[Docket No. 2001-SW-39-AD]

#### Airworthiness Directives; MD Helicopters Inc. Model MD-900 Helicopters

**ACTION:** Notice of proposed rulemaking (NPRM).

**Figure 1. Main Rotor Upper Hub Assembly Inspection.**

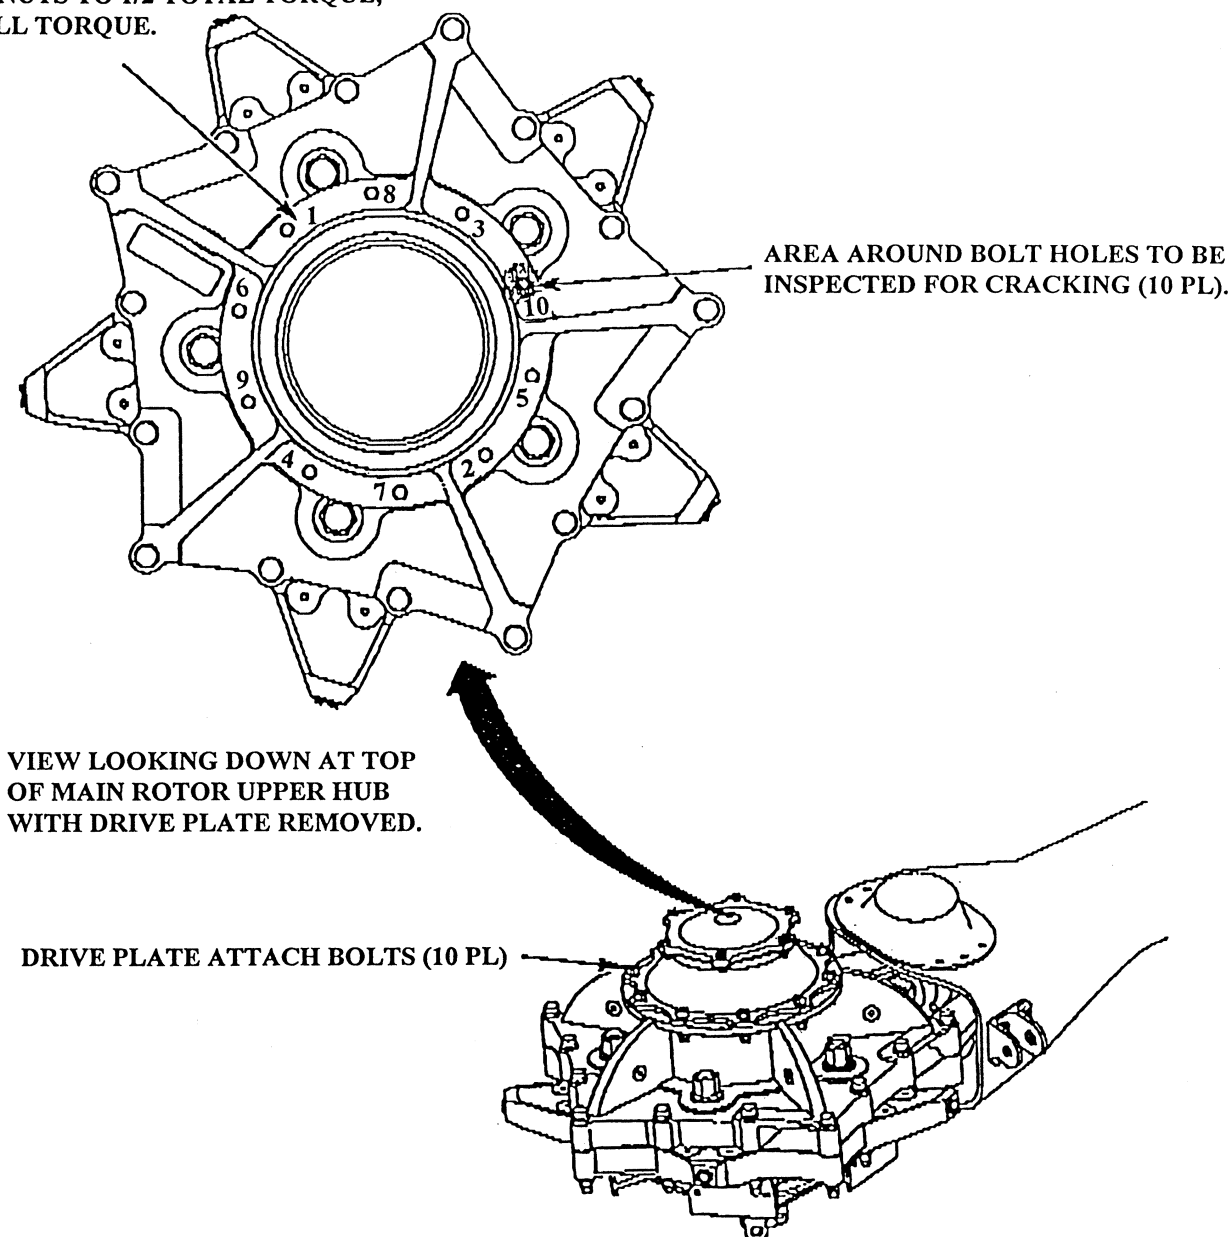
(ii) Mark the main rotor hub holes to correspond with the drive plate hole numbers (see Figure 1 of this AD).

(v) Using paint stripper (Consumable Item List C313 or equivalent) and cleaning solvent (C420 or equivalent), remove the paint from the upper mating surface of the hub assembly to enable an accurate visual inspection of each drive plate attachment bolt hole (bolt hole) area for cracking (Figure 1). Ensure the paint stripper and solvent DO NOT contaminate the upper bearing and upper grease seal areas.

(viii) Reinstall the main rotor drive plate using 10 new sets of replacement attachment hardware. Torque the nuts to 160 inch pounds above locknut locking/run-on torque in the sequence shown (Figure 1). Record in the rotorcraft logbook, or equivalent record, the locknut locking/run-on torque for each nut.

1. MAIN ROTOR DRIVE PLATE ATTACHMENT HARDWARE TORQUE SEQUENCE.
2. NUMBERING MAY START AT ANY HOLE.
3. TORQUE NUTS TO 1/2 TOTAL TORQUE, THEN FULL TORQUE.
